MATERIALS LICENSE

<p>Licensee</p> <p>1. E. R. Squibb & Sons, Inc.</p> <p>2. One Squibb Drive P. O. Box 191 New Brunswick, New Jersey 08903-0191</p>	<p>In accordance with the application dated February 18, 1997,</p> <p>3. License number 29-00139-02 is amended in its entirety to read as follows:</p> <p>4. Expiration date September 30, 2008</p> <p>5. Docket No. 030-05222 Reference No.</p>
---	--

RESPONSE TO NRC REQUEST FOR ADDITIONAL INFORMATION - LICENSE #29-00139-02

July 20, 1998

DET. A
PLAN

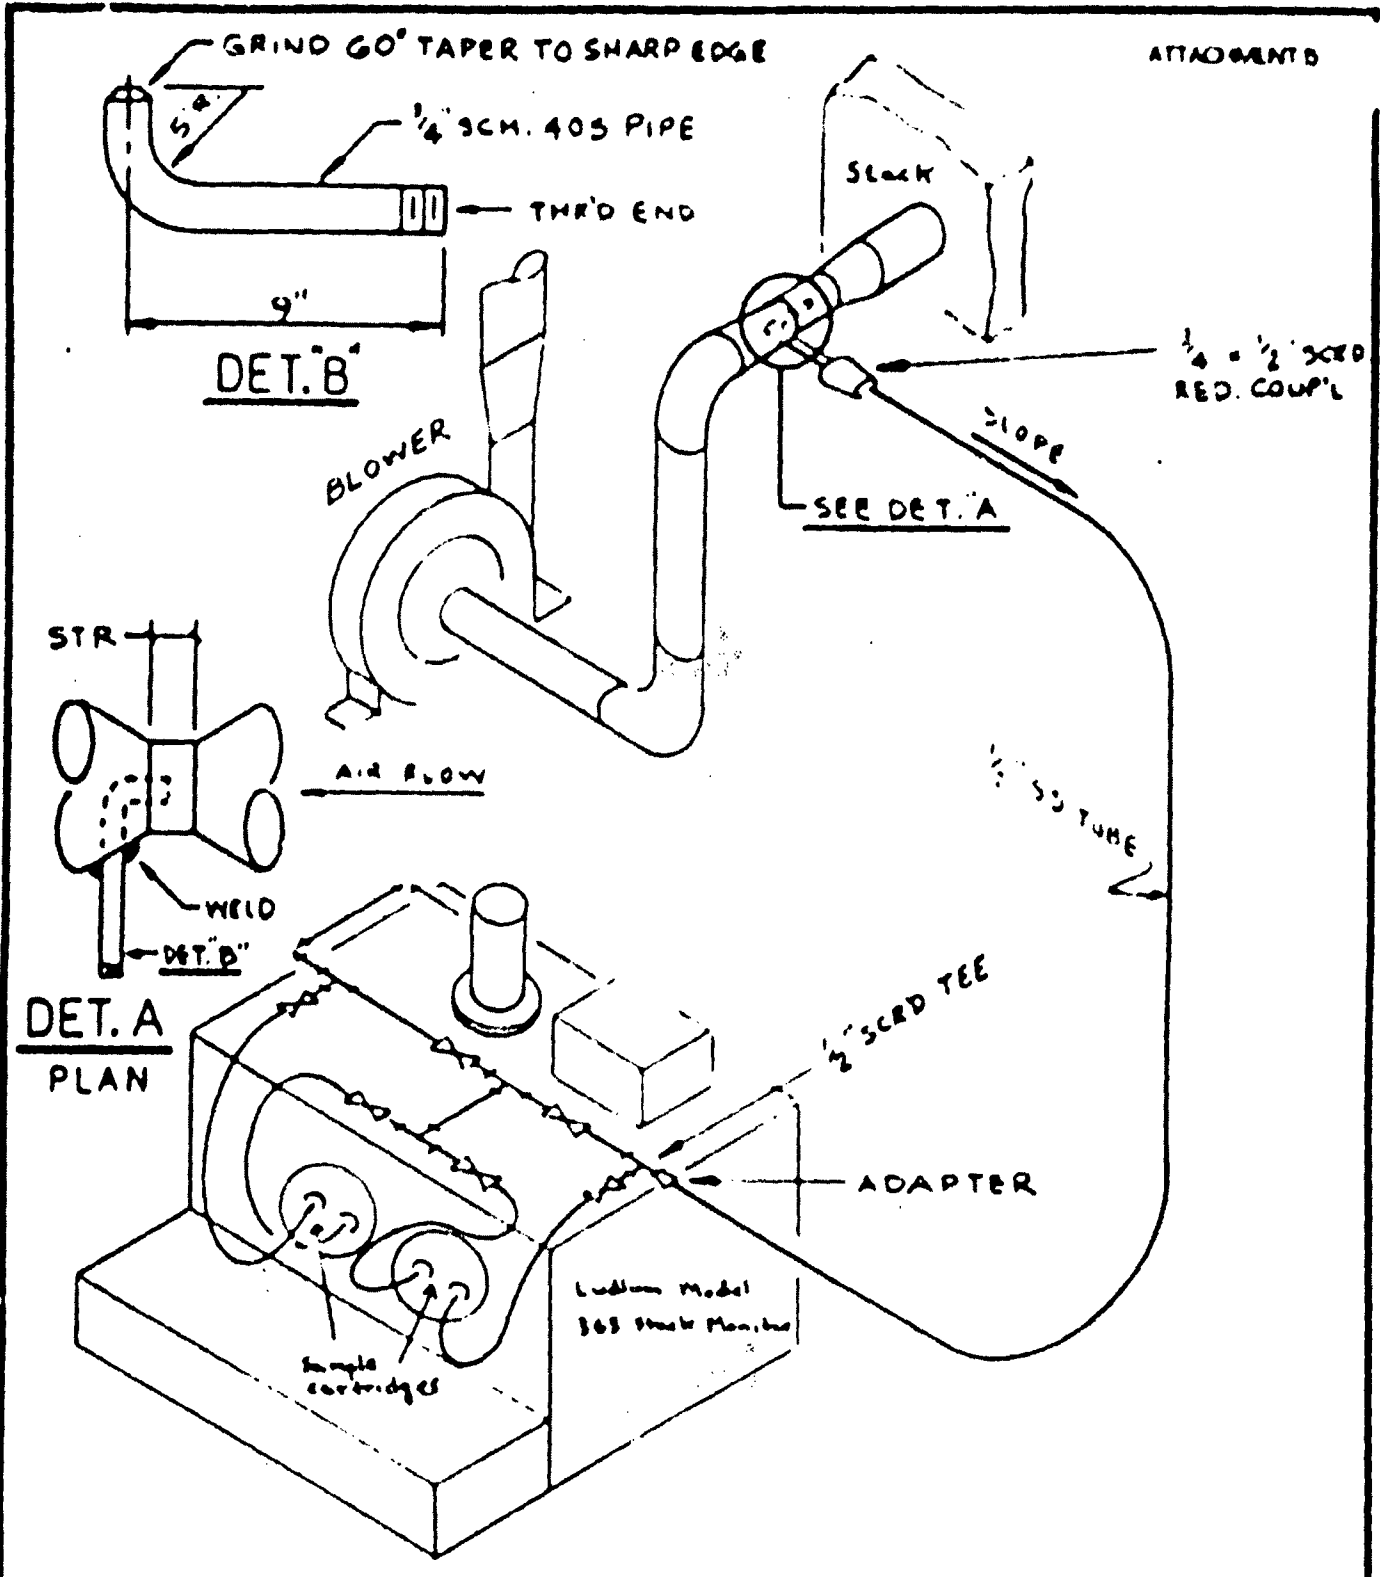
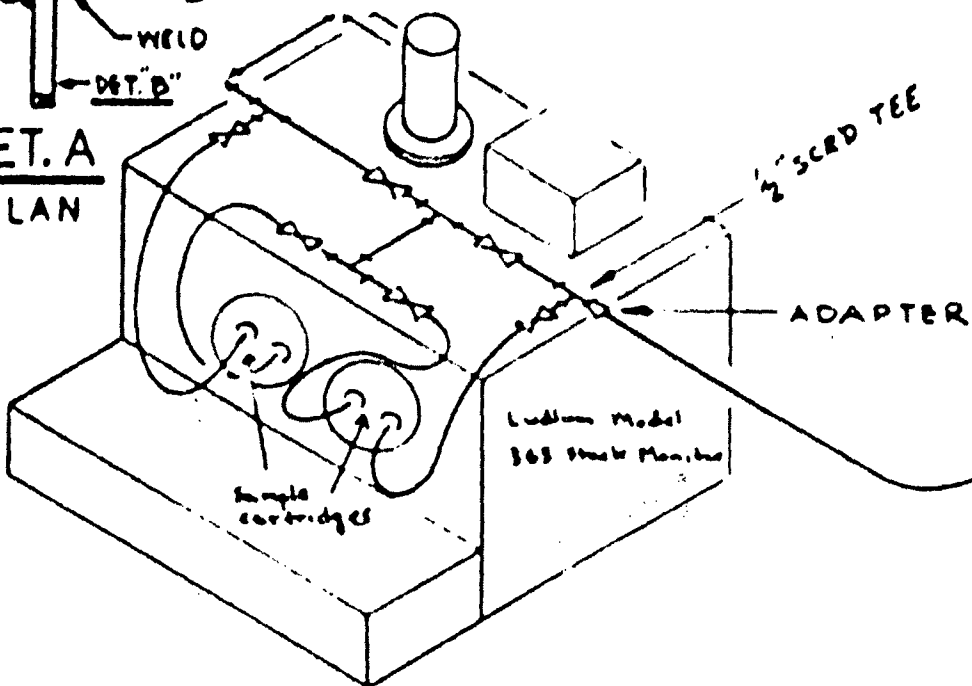
Provide a schematic diagram of all effluent pathways at each site which includes the identification of the source of the activity, the maximum typical activity at each source, the location of the sampling points in each ventilation pathway, and each contributing and final ventilation flowrates for each pathway.

Provide a schematic drawing showing the location of the sample cartridge and the stack alarm detector. Paragraph #5 on page 1-8 states: "The radioactivity in the sampler is constantly measured by the stack alarm detector which will sound an alarm in the Health Physics operations area should the integrated activity representing the 24 hour effluent limit for I-131 as specified in Appendix B, Table II, Column I of 10 CFR 20 be exceeded." Provide specific details about the stack alarm detector, and specify whether the alarm setpoint(s) interact with the HVAC system.

All ventilation systems in the manufacturing area are manifolded to a single stack prior to release to the environment. Page 15, paragraph 5 of the February 18, 1997 license renewal application details the sampling of this effluent pathway. The typical flowrate through this stack is approximately 70,000 cfm, seven days a week, twenty-four hours per day. The primary contribution to the effluent is due to hot cell operations where approximately 35 Curies per week of ^{137}Cs is processed. Each ventilation pathway is monitored by pre and post air sampling tubes as described in Question 2.a above. A schematic of the Building 124 ventilation system is attached (see Attachments 1 & 2).
